Commonwealth Edison

Subject: Byron Station Units 1 and 2
Braidwood Station Units 1 and 2
NRC Docket Nos. 50-454/455 and
50-456/457

This is to provide responses to the Action Items resulting from the Byron/Braidwood Structural Design Audit conducted on October 20 through October 23, 1981.

List of Byron/Braidwood Structural Design
Audit Action Items Addressed

Byron/Braidwood
 FSAR
 Figure 130.18-1
 Plant Layout

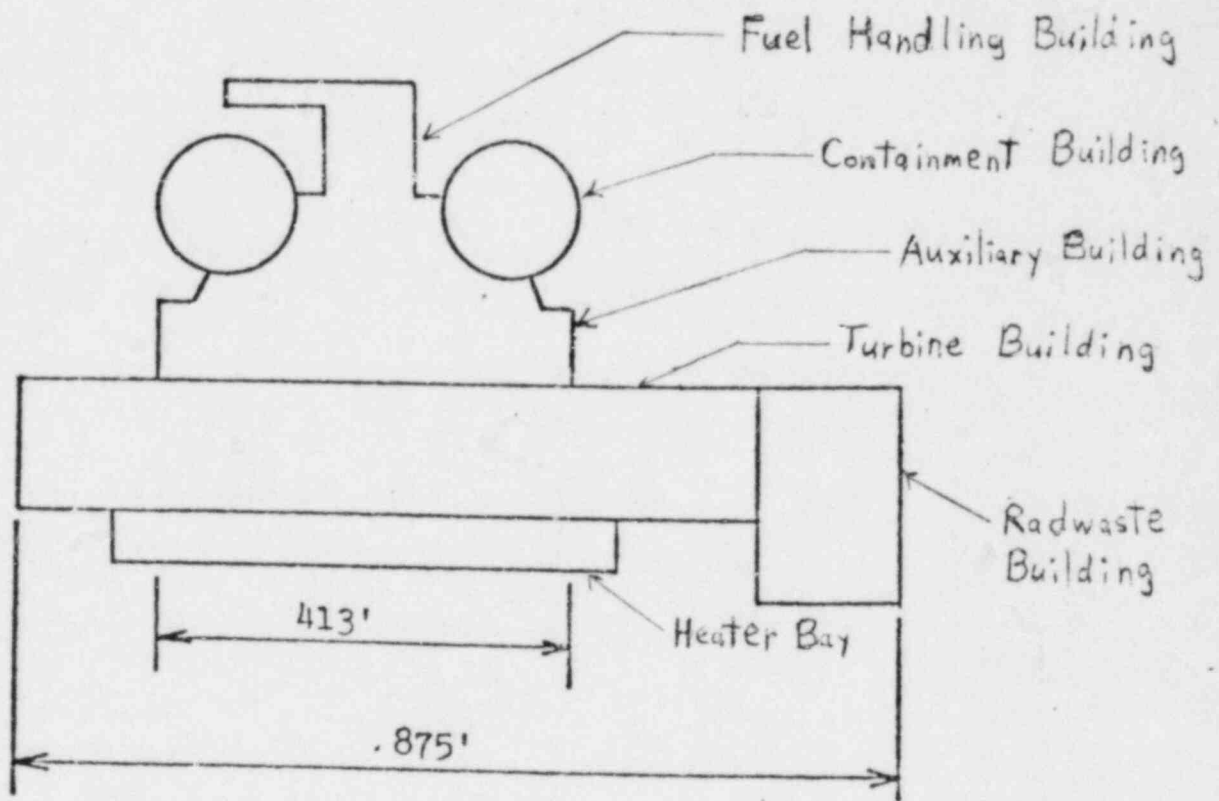
"Your response to Question 130.1 requires further explanation. In Section 3.7.2.11 of the FSAR you stated that the torsional response was accounted for in horizontal building model. Furthermore, you stated in the same section, that the torsional effects were considered insignificant and was not included in the design of Byron/Braidwood structures. The present technical position of the Regulatory staff requires that the accidental torsion, minimum of 5 percent of the base dimension, be included in the design of structure in addition to that which result from the actual geometry of the building. Discuss the rationale of neglecting torsional effects in design of structures and compare, in quantitative terms, the conservatism inherent in the structural design with that which would have resulted if the requirements of the staff were implemented."

The staff position concerning accidental torsion will be implemented for the Byron/Braidwood Category I structures other than the auxiliary fuel-handling building. The Byron/Braidwood auxiliary fuel-handling building is a Category I structure interconnected with the turbine building which is a non-Category I structure.

The Byron/Braidwood plant layout of the auxiliary fuel-handling turbine buildings is shown in Figure Q130.18-1. Major slabs are continuous throughout both Category I and non-Category I buildings; the maximum building dimension is 875 feet. However, the auxiliary buildings, with a maximum length of 413 feet, provides the main shear resisting components.

The horizontal seismic models include the large eccentricities corresponding to the distribution of mass and stiffness for this structure. The eccentricities between the mass centroid for a slab and the center of rigidity of its supporting shear walls results in an average torsional moment of 8% of the maximum building dimension times the story shear for the three major slabs in the Byron plant. Similarly, an average torsional moment of 11% occurs in the Braidwood plant. The amount of torsion considered in the design of the Byron/Braidwood auxiliary fuel-handling turbine building is considerably larger than the 5% minimum required by UBC. It is unlikely that these eccentricities would increase significantly due to any changes other than major changes to the plant structure since the weight of the permanent structural elements accounts for a

substantial percentage of the total mass. Since the plant construction to date is approximately 90% complete, such a change is not feasible, therefore, it is not appropriate to include arbitrary torsion greater than what already exists as a result of actual eccentricities in the auxiliary fuel-handling turbine building.

However, the shear walls of the auxiliary fuel-handling building have been reassessed by considering an additional 5% of the design shear force. When using the actual material strengths, the reassessment has shown that all walls maintain stress levels within the design basis allowables.

SEISMIC CATEGORY I
ELECTRICAL EQUIPMENT HANGERS
TYPE 3H

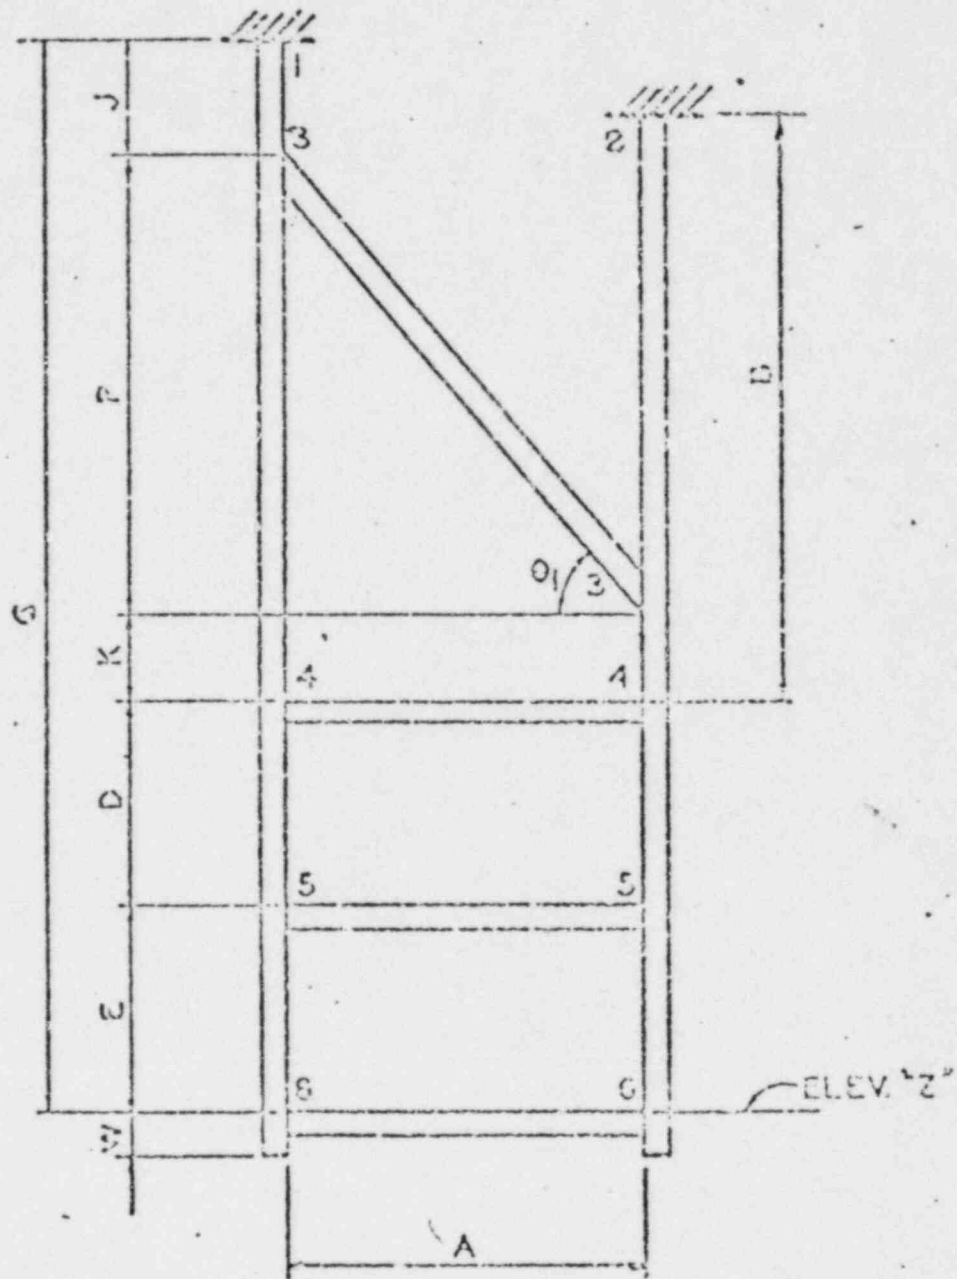
Reference: Telephone Conversation Between
R. Lipinski (NRC) and
R. J. Netzel (S&L),
October 29, 1981

Attached are the computer results for two cable tray supports, H016 & H023, using the OBE response spectra. The results show the supports are designed within the design basis allowable and the members selected for the enveloped design spectra are not changed as noted on page 33 of the output attached.

HQ16: HORIZ: TS 2X2X1/4
 VERT: TS 3X3 X 1/4
 DIAG: P1000

B/B SEB Audit
Action Item 8
Figure 1
Byron/Braidwood
Spectra

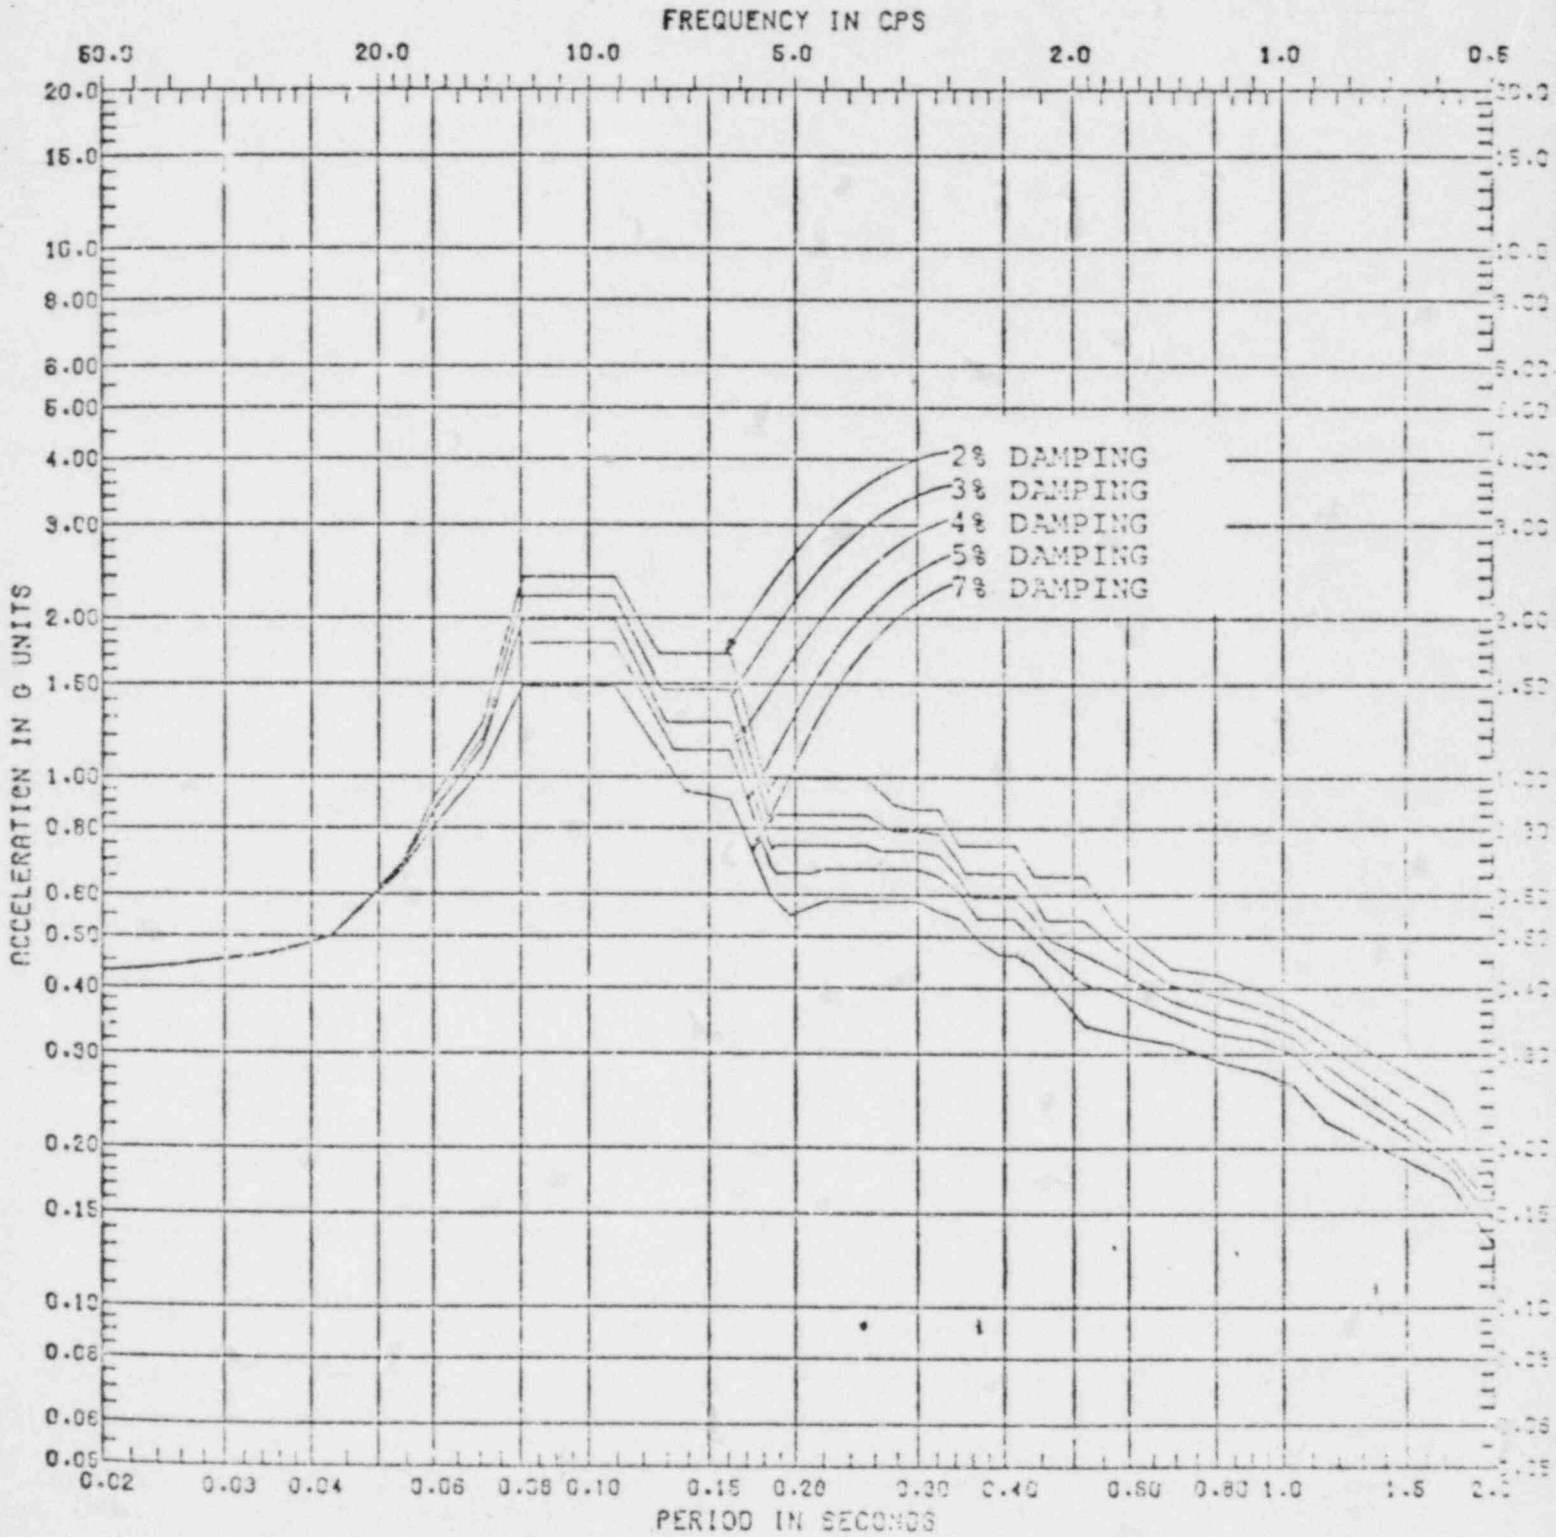
Effect of jerking of the cable in the Crane Analysis.

Check the jerking of the crane bridge cable.

For Byron, max. lifted load is 92 kips. Response spectra has max. response of 2.4g (at 2% damping) at a frequency of 11.0 Hz. The frequency of the Byron crane is 4.1 Hz for main hook, so the loading peak of 2.4g is not in resonance with the structural frequency.

Considering the non-linear analysis, the maximum force on the rope due to SSE will be approximately, by linear interpolation from non-linear study of Zimmer crane,

$$\frac{155.34}{44} \times 92 \times \frac{2.4}{4.0} = 195 \text{ kips}$$

So total force = (195 kips + 101.3 kips) = 296.3 kips < (5x92) = 460 kips (Max. tension during normal operation)

Figure Q/30.5.3-1

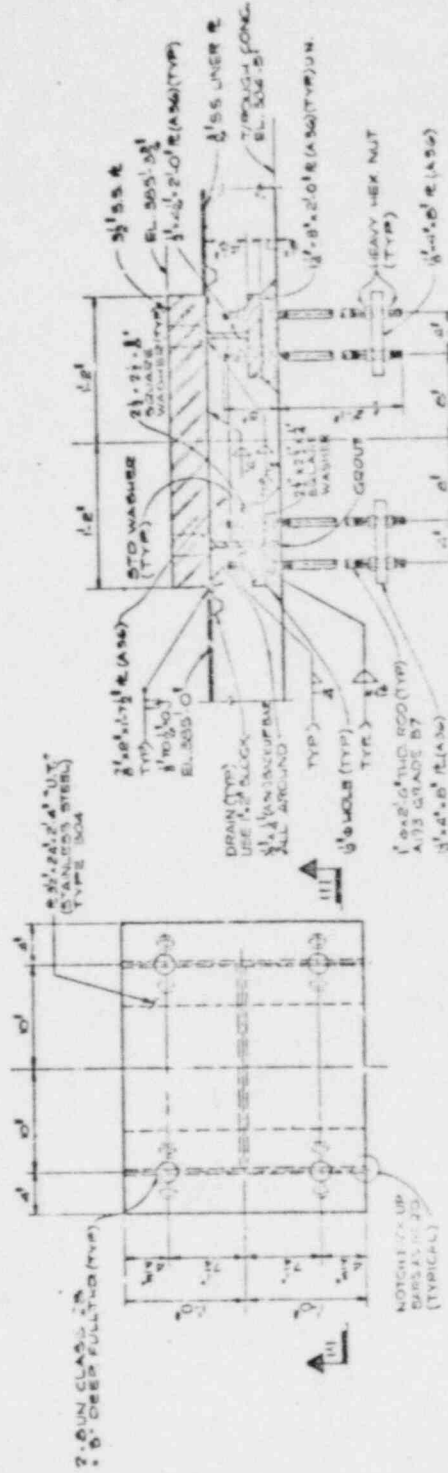
"Because of the unique nature of their function the spent fuel pool racks require special design features. For this reason the Regulatory staff developed the technical position describing the requirements for their design (Attachment 7). State your conformance with this position or identify and justify any deviations therefrom."

1. The cask drop has not been considered in the design of fuel pool because the rails of the fuel handling building crane do not permit the hook of the crane to travel over the spent fuel storage rack area. As stated in Subsection 9.1.2.2, the cask will not fall outside the cask storage area. Figure Q130.53-1 shows the spent fuel storage pool liner plan and Figure Q130.53-2 shows liner details.
